2006/2007 PROPOSED CHANGES TO THE INTERNATIONAL BUILDING CODE – MEANS OF EGRESS

MEANS OF EGRESS CODE COMMITTEE

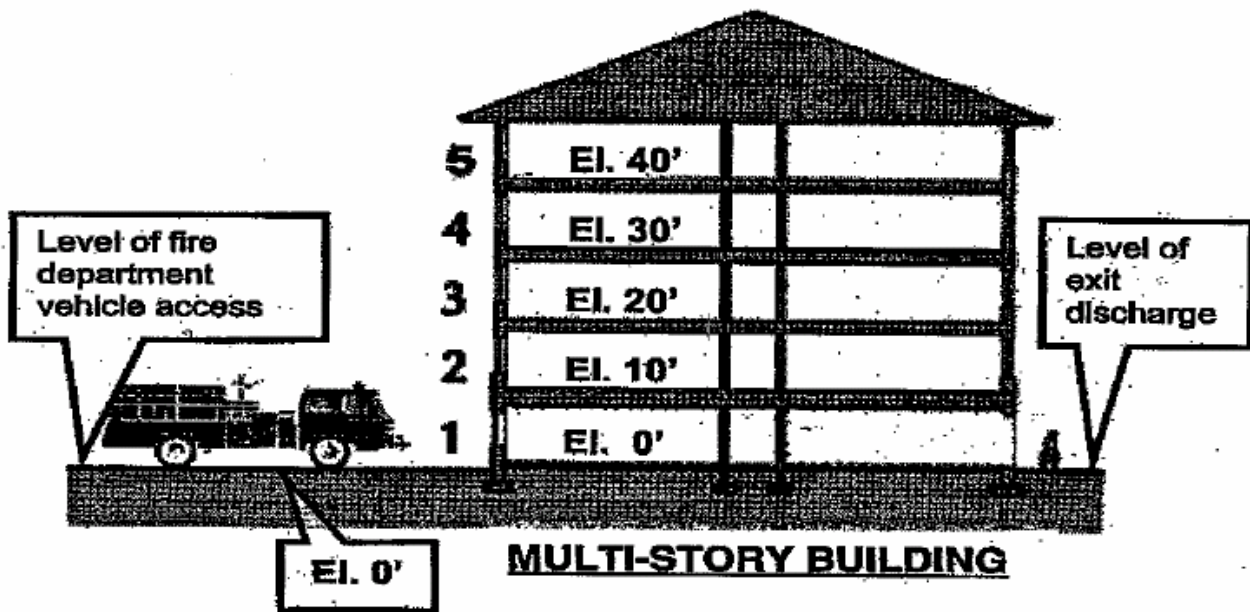
EXIT DISCHARGE, LEVEL OF. The ~~horizontal plane located~~ lowest story at the point at which an exit terminates and an exit discharge begins.

The level of exit discharge as shown in the attached drawing of a Multi-Story Building is at elevation 0.0', the first floor level of the building is also at elevation 0.0'; therefore, the level of exit discharge and the first floor level of the building are at the same elevation. The first story of the building begins at elevation 0.0' (first floor) and extends to the elevation 10.0' (second floor). The first story of the building is the first story above the level of exit discharge.”

The major difference between the IFC formal interpretations and the NFPA 101 definition is that NFPA 101 defines the “level of exit discharge” as a volume (story), not as a “horizontal plane”. Therefore, in the diagram of the multistory building above, the “first story above the level of exit discharge” under NFPA 101 (and for that matter, as used under the legacy codes) was always considered the second story (El. 10'). However, under the IFC Formal Interpretations, it is now the first story (El. 0').

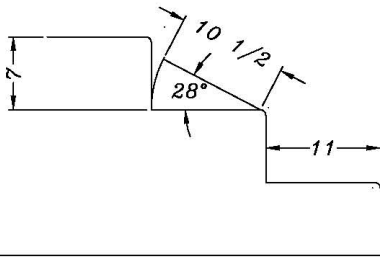
When descending a stair the user places the ball and toes of the foot onto the tread below. From this pivot point the heel then drops in an arc until the foot is balanced on the tread and the weight shift can be completed to swing the other foot to the next tread below. As the heel drops in the arc a nosing projection allows additional clearance for the heel. (see graphic below) The same relief can be obtained by sloping the riser under the upper tread. The word "under" is being added to clarify the intent that the riser may be sloped back into the stair as an alternative to the use of a nosing projection that allows heel relief for the descending user. Currently the code is misinterpreted to allow the riser to be sloped out onto the tread below which causes an effective shortening of the tread depth expected by the user.

In the diagram below an 11 inch tread is shown without a nosing projection. The effective tread depth in descent is diminished when a nosing projection is not used and in the case illustrated the radius at the nosing which is normally provided to reduce wear and chipping at the nosing actually reduces the 11 inch tread depth below that of the 10 inch tread with a nosing projection of 1-1/4 inches. For this reason and others related to the effect of lower risers often used with deeper treads, larger treads should be required to have a nosing projection especially where this is normally provided and expected in residential applications. Please see graphic below illustrating the maximum space available for the heel to arc onto the tread.

No Nosing Projection - shows that foot space of 11 inch tread depth is less than conventional with only 10 inch tread depth and that a change in rise has no effect on foot space.

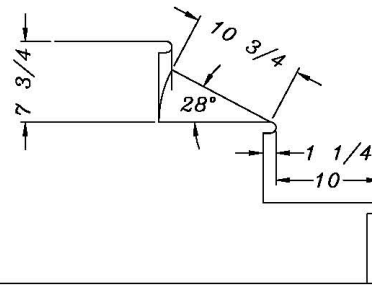
(The following graphic was provided as part of the reason for the IBC and IRC proposed changes.)

Sloped Riser - shows riser angle at 1 1/4 inch projection has less available foot space than conventional

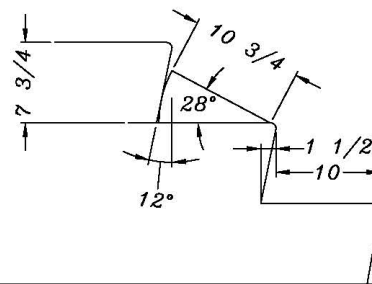
Sloped Riser - shows riser angle and projection required to attain same available foot space as conventional

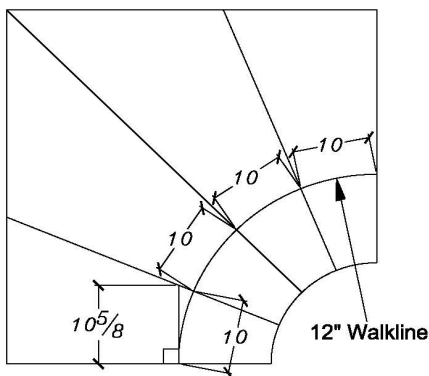
In the ICC codes all treads are recognized to be one of two types, rectangular treads (fliers) with parallel edges and winders treads with nonparallel edges. Both of these treads can be regulated for tread depth at the walk line allowing us to simplify the standard in regard to how tread

depth is measured. Of course since a rectangular tread (flier) has parallel edges, its width can be regulated and measured at any point and it is understood that the code would still require this in order to determine the tread type. This test is required in the IBC because winder treads are not permitted in some egress stairs and both the IBC and IRC regulate winder tread depth at two points. This proposal allowing all treads to be regulated at the walk line offers us the opportunity to simplify the text in regard to the measurement criteria and establish a method that works for all treads.

The tread depth measuring method prescribed by this proposal allows the tread depth to be measured at the intersection of the walk line and the nosing or leading edge of the tread. This is critical to equal division of curved walk lines and the formation of uniform winder treads. This is clearly explained in the attached graphics that show the discrepancies when measuring winders by the current method. The current method is flawed and results in irregular distribution of the treads edges that do not correlate with the user's experience.

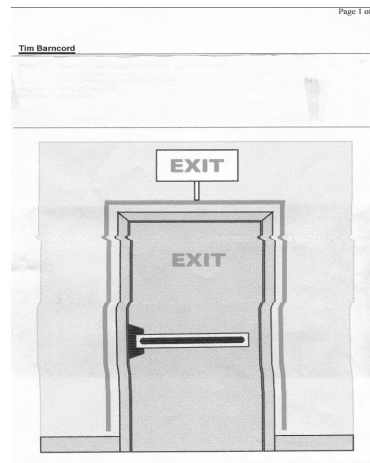
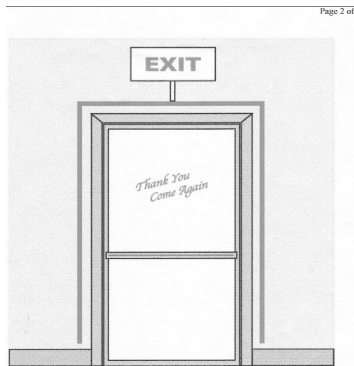
4011.5.3 1011.6.3 Power source. Exit signs and light strips shall be illuminated at all times. To ensure continued illumination for a duration of not less than 90 minutes in case of primary power loss, the sign and light strip illumination means shall be connected to an emergency power system provided from storage batteries, unit equipment or an on-site generator. The installation of the emergency power system shall be in accordance with Section 2702.

Exception: Approved exit sign and light strip illumination means that provide continuous illumination independent of external power sources for a duration of not less than 90 minutes, in case of primary power loss, are not required to be connected to an emergency electrical system.

1011.6.4 Design. Light strips shall have a width of at least 1 inch (25 mm) but not more than 2 inches (51 mm) and be securely attached to the door frame or the wall within 4 inches (102 mm) of the outside edge of the door frame.
